VOLVO PENTA

Service Bulletin

3.0 Liter Engine Upgrades

LK, BY, WT, and EF Models

gr970440

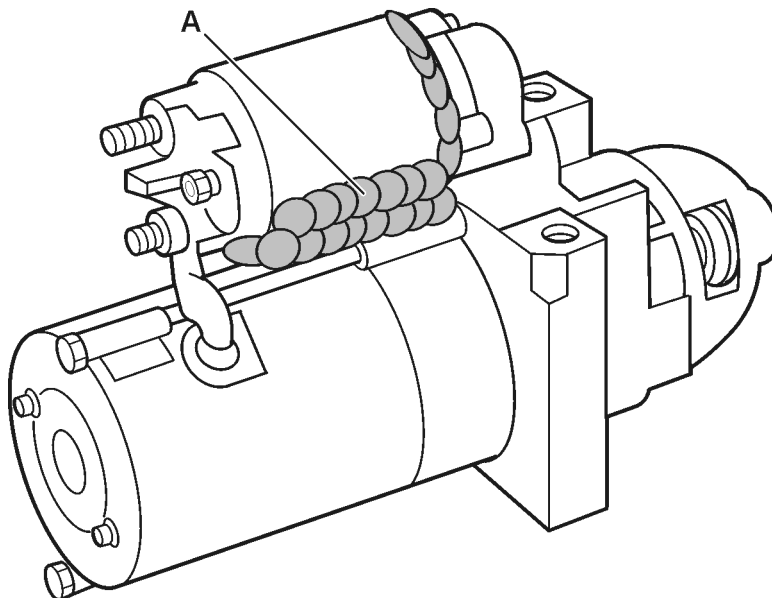
Upgrade No.4 consists of an improvement in the protection of the starter motor.
NOTE! For additional information, please see *Starter Motor* on page 3.

DANGER! Do not substitute an automotive type starter. The Volvo Penta starter motor meets U.S. Coast Guard regulations for external ignition proof operation and marine use. The Volvo Penta starter is specially designed not to cause ignition of fuel vapors in the bilge or engine compartment. The use of automotive type starters can result in fire and explosion.

1. Disconnect the battery ground cable at battery and disconnect all wires at solenoid terminals to prevent sparks in engine compartment.
2. Remove the nut from the starter support bracket. Take out the starter mounting screws and remove the starter assembly.
3. Clean the surface of the starter with electrical contact cleaner or equivalent.
4. Using silicone or RTV sealer, apply a bead in the area indicated below **A**. Seal the gap all around the starter solenoid. Follow the sealant manufacturer's instructions and allow adequate drying time before reinstalling the starter.

1. To reinstall, position the starter assembly on the engine and start the mounting hardware.
2. Snug hardware while holding the starter squarely against its mounting surface. Tighten the screws to 30–36 ft. lb. (41–49 Nm).
3. Connect wires to solenoid and apply black Neoprene dip or equivalent to terminals to prevent corrosion.
4. Reconnect the battery ground cable at the battery. Attach the bell housing drain hose to the solenoid with a tie strap.
